Comhairle Chontae Atha Cliath Theas

Record of Executive Business and Chief Executive's Order

Reg. Reference: SD22B/0232 **Application Date:** 25-May-2022
Submission Type: New Application **Registration Date:** 25-May-2022
Correspondence Name and Address: Matt Barnes 'Coolamber', Stocking Lane, Ballyboden, Dublin 16.
Proposed Development: 2m high front garden boundary wall
Location: 1, Fortfield Road, Dublin 6
Applicant Name: David Hannon
Application Type: Permission

Proposed Boundary Treatment Plan

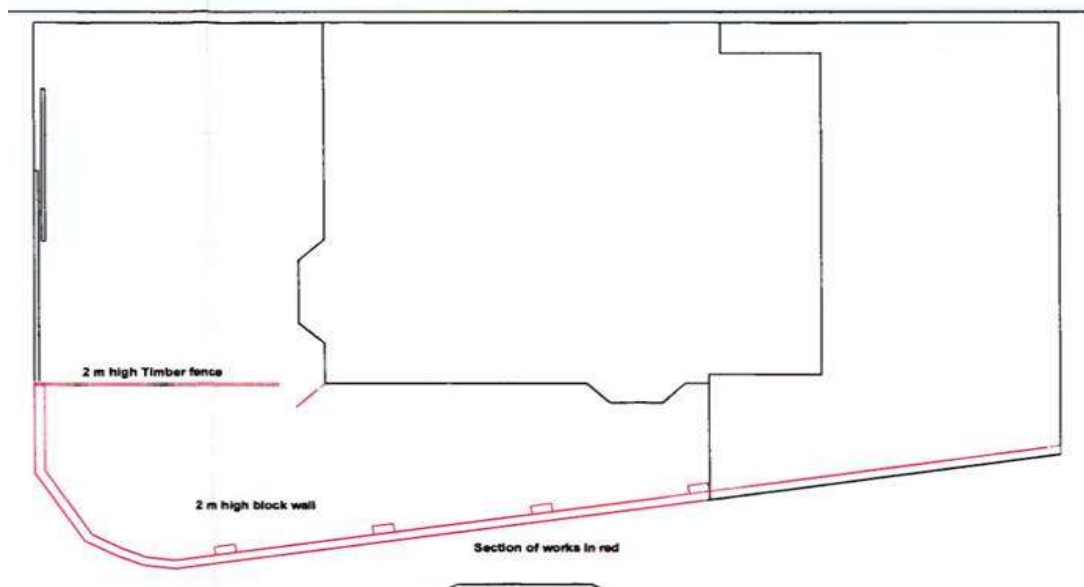
Notwithstanding the Roads report it is considered that to comply with DMURS (4.4.5 Visibility Splay, 4.4.4 Forward Visibility) the provision of a visibility splay of 2.0m x 45m in both directions should be taken from a point 2 metres from **behind** the entrance to allow for the approximate length of a car bonnet and to ensure that any egressing vehicle does not encroach on the footpath before pedestrians can be observed. With this criteria applied to the situation at hand whereby a 2 metre high boundary will be constructed in part of the front garden, along the side/front garden and also considering a 2m high timber fence will be construction (not in description of works but attached below) in the front garden in line with the side building line of the dwelling this will not allow for any form of visibility and would not comply with DMURS (4.4.5 Visibility Splay and 4.4.4 Forward Visibility) and would endanger public safety by reason of a traffic hazard.

However, as discussed, the proposed increasing of the side boundary from c.0.7m to c.2m **from behind the main front building line** would be likely to be acceptable in terms of appropriate sight lines and visibility splay and the proposed increase in rear boundary wall height from 1.7m to 2.0m would be acceptable.

To address the above it is considered appropriate that the applicant submits revised plans and elevations by way of **additional information** clearly showing for the omission of any increase in boundary height beyond the main front building line of the existing dwelling. This would require the omission of part of the front boundary wall, timber fence and the side wall where it projects beyond the main front building line of the existing dwelling. This further information should also show adequate sight lines for vehicles exiting the site are maintained.

Proposed Boundary Treatment Front Elevation

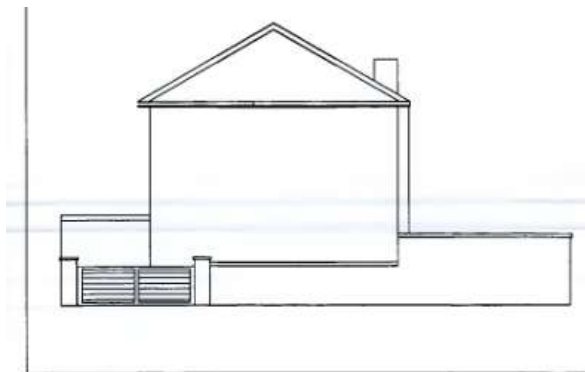
From a visual amenity perspective and vehicular sight lines, the increase in boundary height **beyond the front building line** of the existing dwelling would not be acceptable. It would have an adverse impact on traffic safety as appropriate visibility splay would not be achieved for vehicles to safely access and egress from the site. Therefore, the proposed increase in height of part of the front boundary wall and the proposed timber fence in the front garden would not be acceptable. This is discussed in further detail in the Access & Parking Section of this report. However, the proposed increasing of the side boundary from c.0.7m to c.2m **from behind the main front building line** may be acceptable. The proposed increase in rear boundary wall height from 1.7m to 2.0m would be acceptable.

1. The applicant is requested to submit a revised plan and elevations clearly showing for the omission of any increase in boundary height beyond the main front building line of the existing dwelling. This would require the omission of the increase in height of part of the front boundary wall, all of the timber fence in the front garden in line with the side building line and the side wall where it projects beyond the main front building line of the existing dwelling. The proposed increasing of the side boundary from c.0.7m to c.2m from behind the main front building line would be likely to be acceptable in terms of appropriate sight lines and visibility splay. The proposed increase in rear boundary wall height from 1.7m to 2.0m would be acceptable. The applicant is requested to liaise with SDCC Roads Department to ensure acceptable sightlines.

Proposed Boundary Treatment Side Elevation

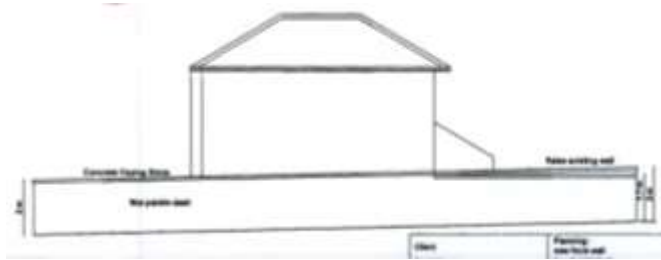
As there are 2 no. windows located at first floor level on the side elevation (north) of the existing dwelling the proposed increase in height of the side boundary wall behind the main front building line will not have a significant adverse impact on the passive surveillance of the public realm and would visually accord with the character of the area.
